UNITED STATES PATENT AND TRADEMARK OFFICE

APPLICATION NO.	FILING DATE	FIRST NAMED INVENTOR	ATTORNEY DOCKET NO.	CONFIRMATION NO.
09/838,356	04/19/2001	Karl Jacob Haltiner JR.	DP-304959 (DEP-0197)	2480
22851	7590	03/08/2005	EXAMINER	
DELPHI TECHNOLOGIES, INC. M/C 480-410-202 PO BOX 5052 TROY, MI 48007			WILLS, MONIQUE M	
			ART UNIT	PAPER NUMBER
			1746

Office Action Summary

DETAILED ACTION

FIG. 1

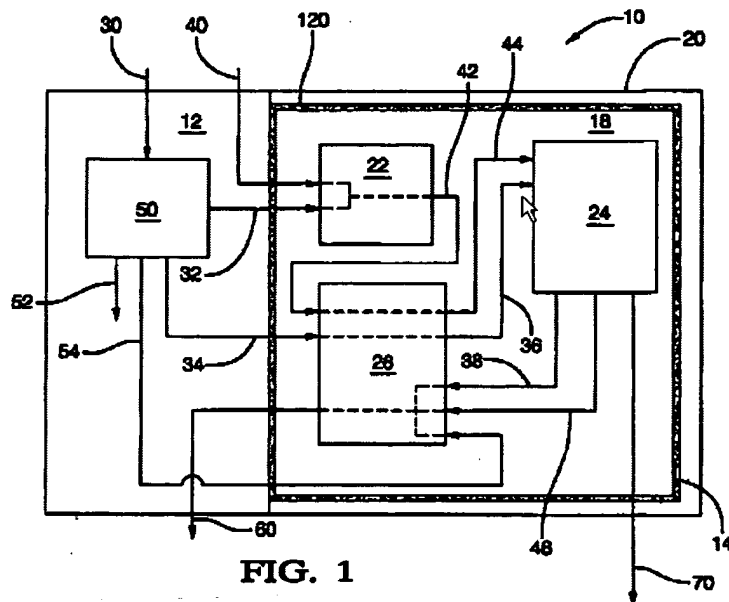
With respect to claim 26, Armstrong teaches a method of producing electricity in an auxiliary power unit of a vehicle comprising: adding a fuel (40) and a reactant (32) to a fuel reformer (22); producing a reformat (42) at said fuel reformer (22); introducing said reformat (42) to a fuel cell stack (24); producing electrical power at said fuel cell stack (24); sensing a reformer zone temperature at a reformer zone (18); determining whether said reformer zone temperature is at a first selected temperature range; and adding a first process (32) air flow to said reformer zone (18) if said reformer zone temperature rises above

said first selected temperature range. See Figure 1, and column 2, lines 1-5. As to claim 29, the first process airflow is controlled via a first air control valve. See column 3, lines 10-15.

As to claim 31, the method further comprises: sensing a hot zone temperature at the hot zone (26); determining whether said hot zone temperature is at a second selected temperature range; and adding a second process air flow to the hot zone if the hot zone temperature rises above the second selected temperature range (col. 2, lines 55-65).

As to claim 34, the method further comprises controlling the second process airflow via a second air control valve (col. 3, lines 10-15). With respect to claim 35, the method further comprises moving reformer air (42) to the hot zone (26). As to claim 36, the method further comprises moving hot air to a waste energy recovery unit (26).
